LITTLE CREEK BRIDGE

D.H.O. FOUNDATION INVESTIGATION
REPORT.
W.J. 62-F-1 -- W.P. 246-61.

Re: W.P. 246-61, Highway 54, Little Creek
Bridge and Approaches, District 4.

July 9, 1962.
REVIEW OF PRELIMINARY PLAN -
D-5076-P1. Little Creek Bridge,
Hwy. #54, District #4,
W.P. 246-61.

APPROVED _____		SITE No. <u>1-17</u>	W.P. No. <u>246-61</u>
DESIGN	BRIDGE ENGINEER	CONTRACT	
DRAWING	CHECK	Nos.	
<u>D.L.K.</u>	<u>E.A.</u>		
	CHECK		
	<u>D.L.K.</u>		
DATE	LOADING	DRAWING	
<u>MAY 1962</u>	<u>4 20</u>	No.	<u>D-5076-P1</u>
	<u>5-16</u>

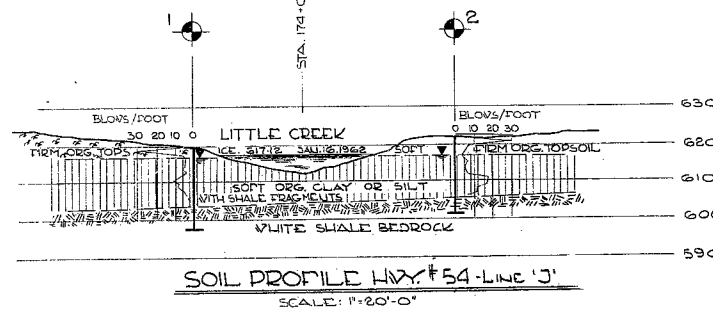
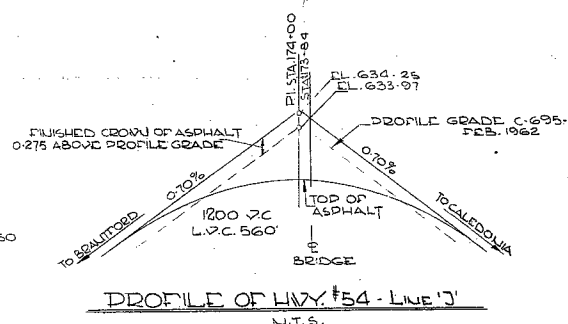
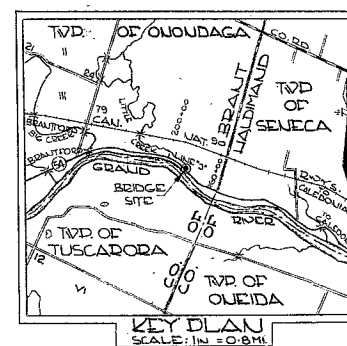
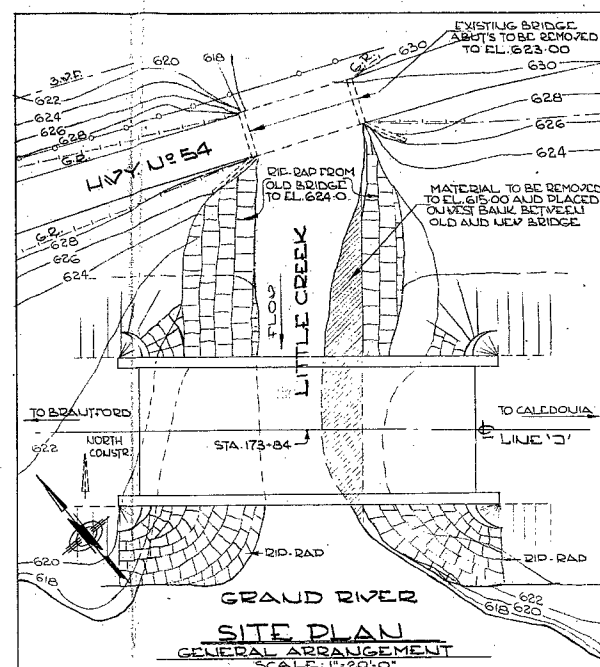
We have reviewed your Preliminary Plan D-5076-P1,
for the above structure and submit the following comments:-

The present proposals call for a three span structure with the abutments supported on piles driven through the 15 feet high approach fills to bedrock, and piers consisting of vertical piles driven to bedrock and capped at bridge seat level. Subsoil consists of about 15 to 18 feet of soft organic clay or silt, with shale fragments. We believe that the proposed embankments will be stable, but in the light of past experience with a similar type of structure and similar subsoil conditions (15-Mile Creek), we feel that measures should be taken to provide more lateral support for the pier piles. We therefore recommend that prior to constructing the approach embankments, the organic material in the stream bed for a depth of about 6 feet should be removed and replaced with suitable granular fill. This procedure should be carried out from Sta. 173+64 to Sta. 174+04 for a width of about 25 feet each side of Centre Line. This measure, if carried out, will not only provide more lateral stability for the pier piles, but will also improve the stability of the forward slopes of the proposed embankments.

In view of the fact that settlements are likely to occur under the proposed embankments, we recommend that final paving of the approaches be postponed for a period of about 12 months.

Along with this memo is a copy of a memo I received from Mr. K. G. Selby of the Foundations Section. Mr. Selby recommends that the organic material in the stream bed be replaced with a suitable granular for a depth of about six feet, prior to driving the piles. The extent of the replacement is indicated in the memo from Foundations Section. This is to provide more lateral support for the pier piles and improve the stability of the forward slopes of the embankment. These recommendations have been made by the Foundations Section in the light of past experience with a similar type of structure and similar subsoil conditions (15 Mile Creek). I suggest that these recommendations be adopted and provided for in the final contract.

The memo from the Foundations Section also recommends that the paving of the approaches be postponed for a period of about 12 months to provide sufficient time for the embankment to settle. Would you consider this point when writing your B4 and special provisions.

Temporary bracing of the pile bents is recommended during the construction of the bridge. The bracing will be required during two stages of construction. The piles should be braced along both axis of the pier bent until the time the pier cap is completed.

After the completion of the pier bents and until the precast concrete deck units are placed the pier bents should be braced in the longitudinal direction of the bridge to ensure that the correct spacing and position is maintained. This has not been shown on the drawings, but should be provided for in the special provisions.
